01		See Note A	03-14-2022			
Ed	Position	Modified from	Date	Intr./Appd.	Parent 3D model	Ed . Version 3D

Name									
Material See Drawing									
Treatment									
 		Scale 1 : 5		Family		Compare		Drawing Owner	Transferred from
		Drawn by a90004135		Blank nr.		Replaces			
STATUS		Drawing format A3		Blank wt Kg		Fin. wt. 2.208 kg		Designation Sheet 1 / 2	
		Des checked.		Prod checked.		Approved.		Date 19-11-2021

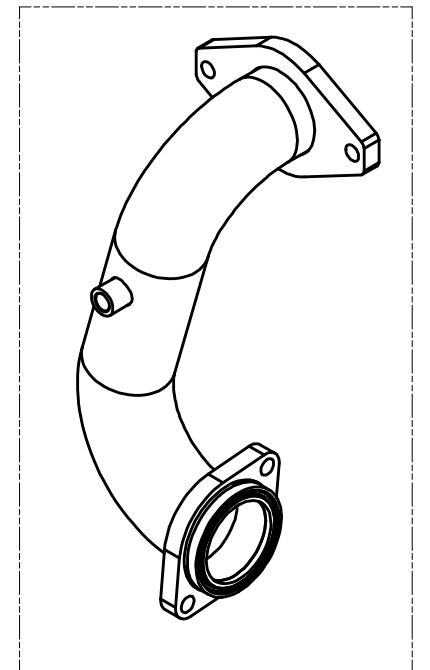
- Bending radius is changed from 76 to 75.
- Welding socket position is changed.
- Dim. 106 & 53.5 are added.
- Weld Socket dia. changed from 17.5 to 20.
